# AIA® Document G701® – 2017

## Change Order

<b>PROJECT:</b> <i>(Name and address)</i> Mansfield ISD 2024 Bond Program - A4 Lake Ridge High School Baseball/Softball Turf & Batting Cages 101 N. Day Miar Rd. Mansfield, TX 76063	<b>CONTRACT INFORMATION:</b> Contract For: General Construction  Date: May 28, 2025	<b>CHANGE ORDER INFORMATION:</b> Change Order Number: 001  Date: March 05, 2026
<b>OWNER:</b> <i>(Name and address)</i> Mansfield Independent School District 605 East Broad Street Mansfield, Texas 76063	<b>ARCHITECT:</b> <i>(Name and address)</i> Huckabee & Associates, Inc. 800 Cherry Street, Suite 500 Fort Worth, Texas 76102	<b>CONTRACTOR:</b> <i>(Name and address)</i> Crossland Construction Company, Inc. 13601 N. Freeway, Ste. 130 Fort Worth, Texas 76177

*(Insert a detailed description of the change and, if applicable, attach or reference specific exhibits. Also include agreed upon adjustments attributable to executed Construction Change Directives.)*  
Final project reconciliation deductive change order.

**RE: Mansfield ISD – Lake Ridge High School BB SB Turf Batting  
Gutter and Downspout Modifications**

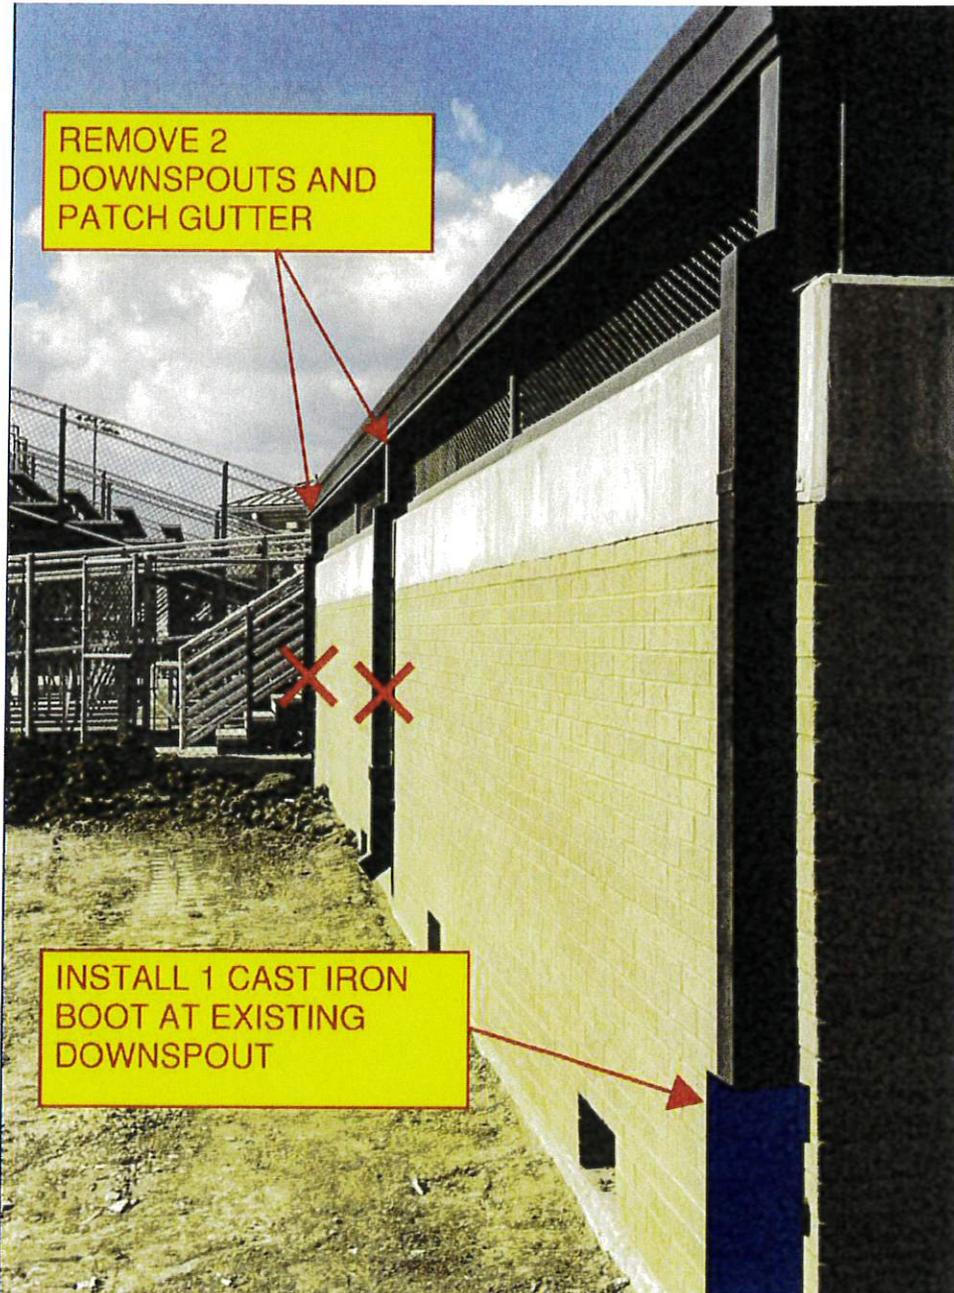
- Remove existing downspouts – return cast-iron boots to owner
- Patch gutter where downspouts were removed
- Provide and install ~~two (2)~~ cast iron downspout boots one (1)
  - Prime and paint to match existing downspout color
  - Connection to underground piping by others

**NOTES:** Proposal includes work on ~~two (2)~~ dugouts.  
one (1)

~~\$3,550~~  
\$1,775
